NUMBER
13-01-050

Technical Service Bulletin

MODEL(S)
VELOSTER (FS)

**SUBJECT: VELOSTER WASHER FLUID LEVEL SENSOR REPLACEMENT
(SERVICE CAMPAIGN TR6)**

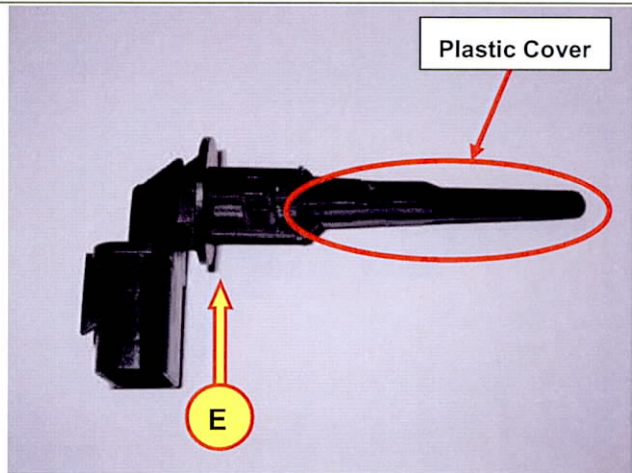
DESCRIPTION: On some Veloster vehicles, the washer warning signal may illuminate even though the washer fluid level is full. This bulletin provides the procedure to replace the washer fluid sensor.

7. Remove the plastic cover and install the new washer fluid level sensor (E) with part number 98520-2V000-QQH.

PART NAME	PART NUMBER		REMARKS
	PREVIOUS	NEW	
LEVEL SWITCH- WINDSHIELD WASHER			1EA
	98520-2V000	98520-2V000-QQH
